RE: Variance Committee Review to allow for **Category F Driveway****Applicant/Property Owner:** ACME Improvement District**Palm Beach County City of Wellington State Road: 7 Section: 93210000 MP: 21.1****Access Class: 03 Posted Speed: 50 mph SIS: N/A****Site Acreage: 70 Acres Development Size: 15 Multifamily Residential DU (Low-Rise); 180 Room Hotel; 1,750 Student Private School (K-12); 80,000 SF Office; 285,000 SF Shopping Plaza (Including +/- 80,000 SF Restaurant; 31,396 SF Church (existing))****Project Name & Address: K-Park - 10400 Stribling Way****AMRC Meeting Date: 9/4/2025, 11:15 AM****Request:**

Bryan Kelley – K-Park Access Management Review Committee Letter

K PARK
SECTION 24, TOWNSHIP 44S, RANGE 41E,
VILLAGE OF WELLINGTON, FLORIDA
DRIVEWAY ENTRANCE MODIFICATION EXHIBIT

OPTION 2G
FULL TRAFFIC SIGNAL
W/ INTERNAL ROUNDABOUT

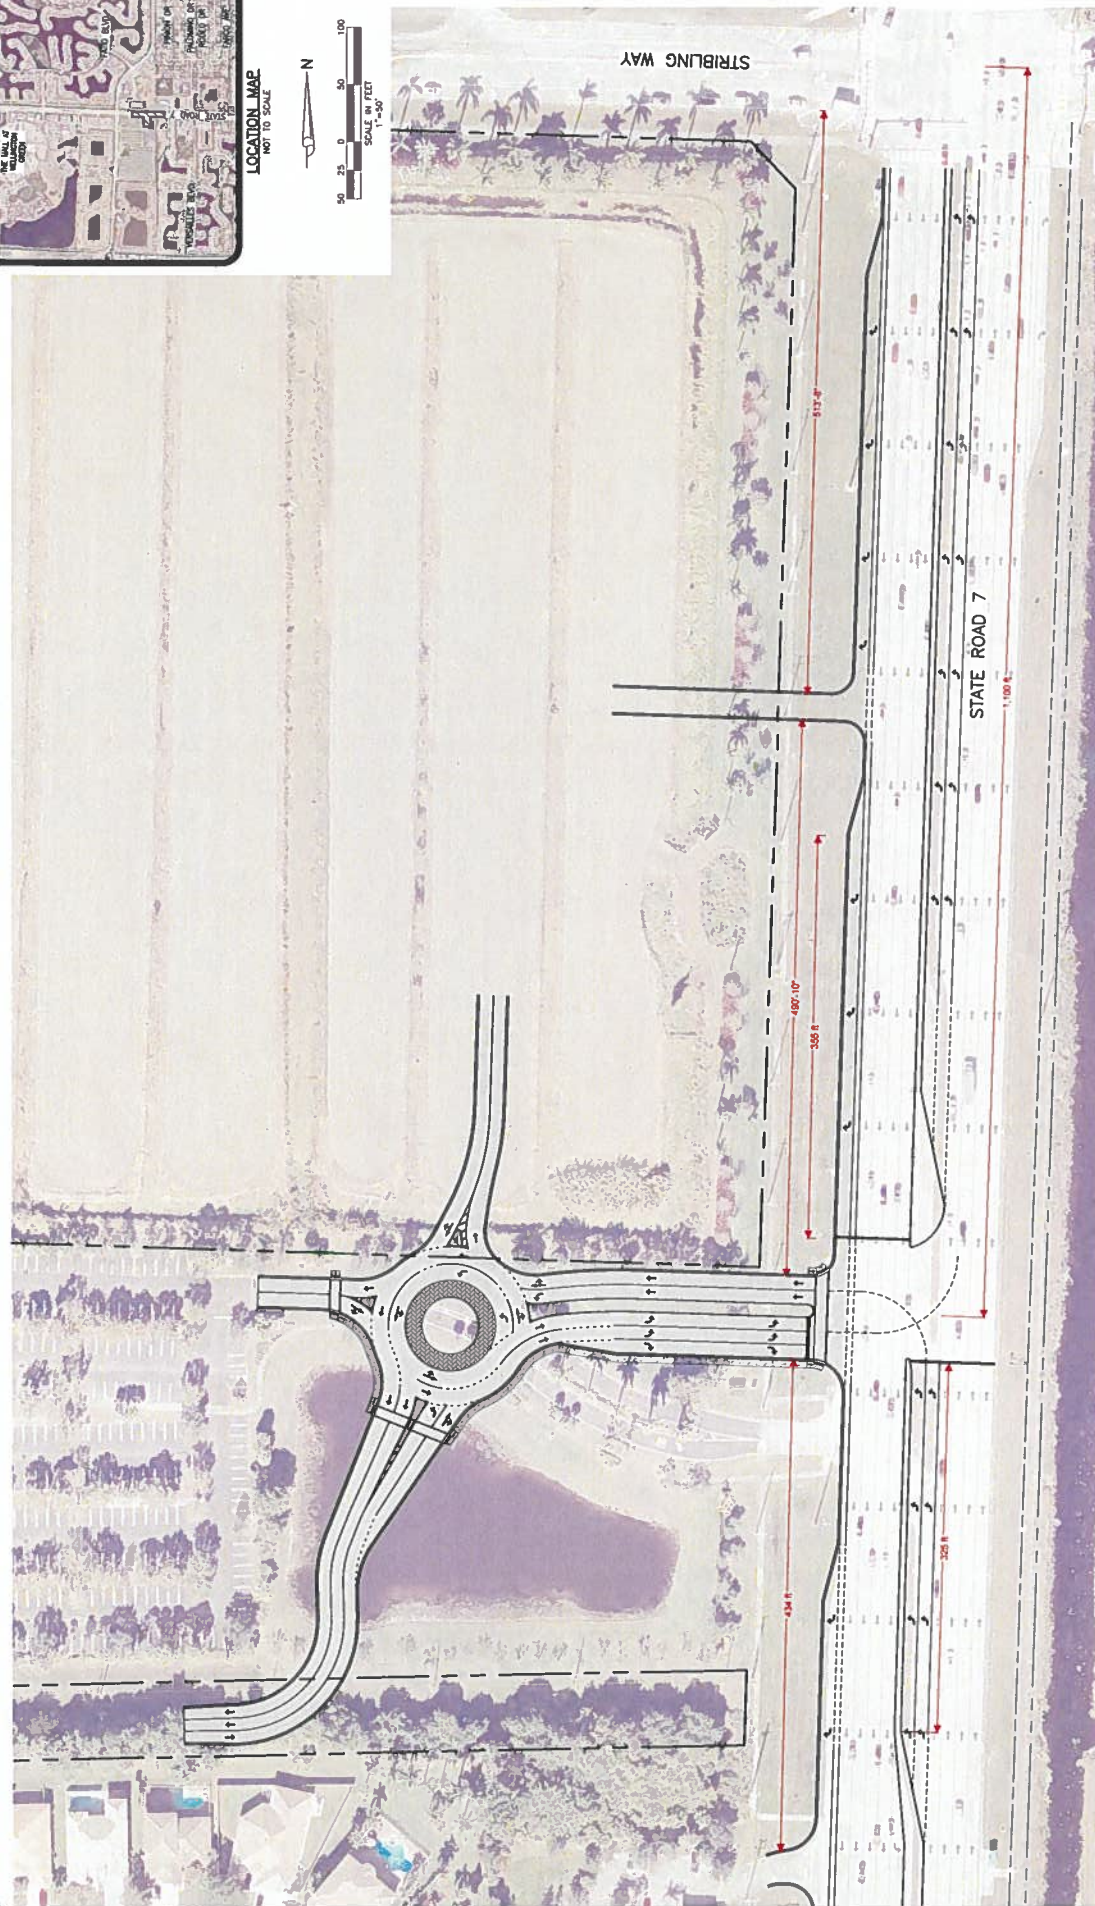
- **Driveway 1:** Proposed right-in/right-out driveway with right turn lane on the west side of SR 7, located approximately 514 feet south of Stribling Way.
- **Driveway 2:** Proposed signalized intersection on SR 7, located approximately 1,029 feet south of Stribling Way.
- Close the existing right-in/right-out/left-in driveway on the west side of SR 7, located approximately 1,153 feet south of Stribling Way.
- Remove the existing directional median opening on SR 7, located approximately 1,029 feet south of Stribling Way.

- ☐ Driveway 1 shall have a minimum driveway length of 100 feet, measured from the ultimate right-of-way line to the first conflict point in the driveway.
- ☐ The proposed signalized intersection (Driveway 2) shall have a minimum driveway length determined by a traffic study conducted by the applicant.
- ☐ The proposed multilane roundabout shall follow nationwide design guidelines (FDOT FDM Chapter 213). Queuing from the multilane roundabout's eastern approach must not encroach onto SR 7, as determined by a traffic study conducted by the applicant at permit.
- ☐ Right turn lanes are required for Driveways 1 & 2 and shall meet the minimum requirements in the Florida Design Manual (FDM) and shall provide space for a buffered bicycle lane.

- ☐ The queue length for the proposed northbound dual left turn lanes at Driveway 2 and the proposed dual northbound left turn lanes at the intersection of SR 7 and Stribling Way, must be determined by a traffic study conducted by the applicant at permit.

- ☐ An Intersection Control Evaluation (ICE) Analysis conducted by the applicant at permit, is required for Driveway 2.
 - ☐ The proposed traffic signal support system shall have the structural capacity to implement a minimum of one signal head per lane with five section heads for all three approaches, as needed.

- ☐ The following off-site improvements shall be implemented at the intersection of SR 7 & Stribling Way, by the applicant:
 - An additional northbound left turn lane. The intersection shall be served by dual northbound lefts.

- An additional eastbound right turn lane.
 - An additional eastbound left turn lane.
 - Extend the southbound right turn lane to meet minimum length as determined by a traffic study conducted by the applicant at permit.

- All existing driveways not approved in this letter must be fully removed and the area restored.
 - Additional right-of-way must be donated to the Department to implement the proposed improvements and mitigation, as needed.

- Drainage mitigation is required for any impacts within FDOT right-of-way (i.e. increased runoff or reduction of existing storage).
 - A Storm Water Pollution Prevention Plan must be submitted with the application if there will be more than one acre of "disturbed area" (as defined by the Florida Department of Environmental Protection (FDEP)).

This request is: **Approved with Conditions****Conditions:**
